## Dharma Cloud Foundation

California Coastal Commission  
Att.: Melanie Faust  
710 E Street, Suite 200  
Eureka, California 95501

Items F 5a, F 6a - 1-06-PWP  
Item F 8c - 1-06-022  
June 13, 2006  
Ten Mile Bridge Replacement Project

**FIG. 3.—Colorado Absolute Width Curve**

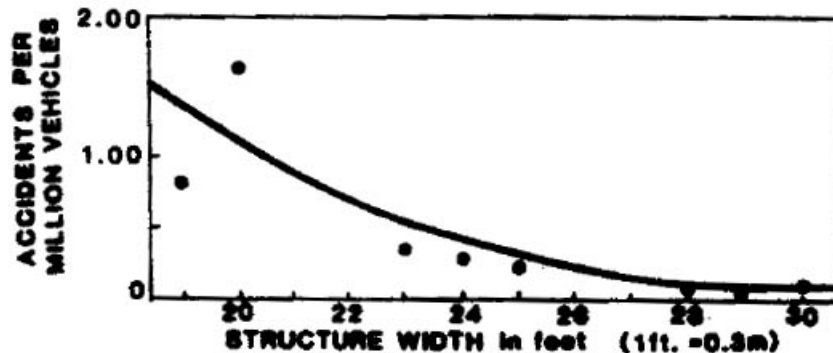
Figure 3 from this study shows that accident rates are extremely small for bridges equal to or greater than 28' wide, and further, that there is no meaningful decline in accident rates for bridge widths beyond 28'. With 4' shoulders, the new Ten Mile bridge would have a traveled way of 32', well into the flat portion of the curve; thus further increases in width would not reduce predicted accident rates.

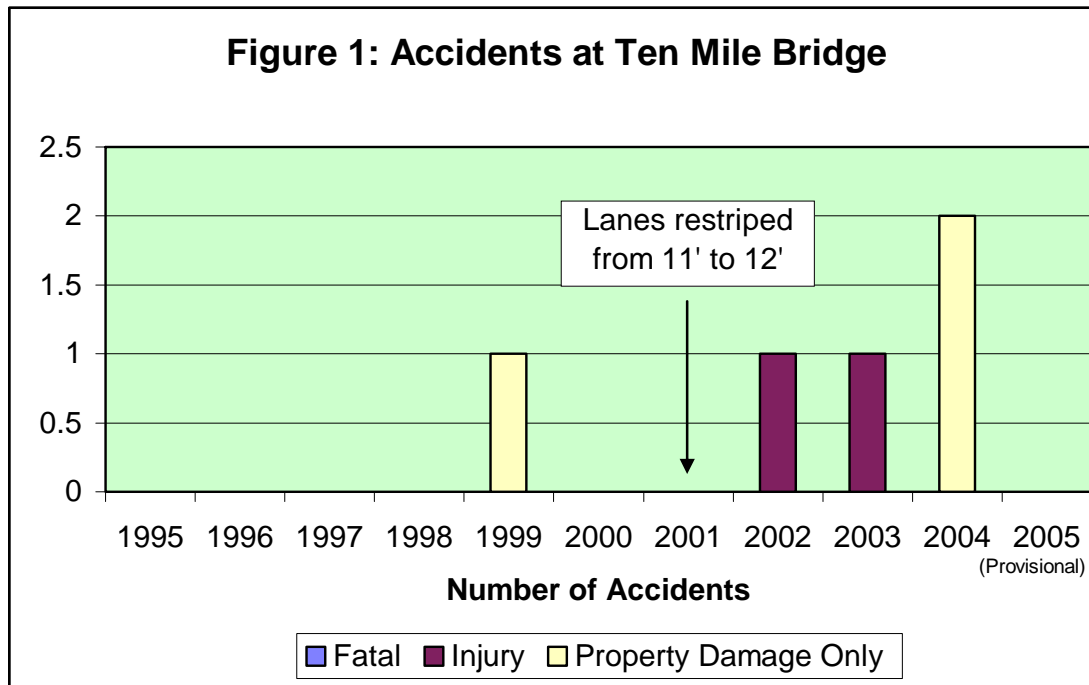
Figure 1 shows the accidents reported from 1995 through 2005 on Ten Mile Bridge.<sup>13</sup> Strikingly, there was only one accident in 6 years prior to the restriping, whereas there were four accidents in four years following the restriping – a six-fold increase in accident rates. The difference is great enough to suggest that the wider lanes encouraged higher speeds, that in turn resulted in more accidents.<sup>14</sup>

The implication of the accident experience is that the bridge was safer for drivers when more of the width was devoted to shoulder space. On the new bridge, the shoulders will be much wider than on the old, but to the extent that the narrower lane slows down drivers, having an 11' instead of a 12' lane will enhance safety.

Although the Commission may not want to make it a condition of approval that shoulders be five feet wide and lanes eleven feet wide, I urge the Commission to strongly recommend this configuration to Caltrans.
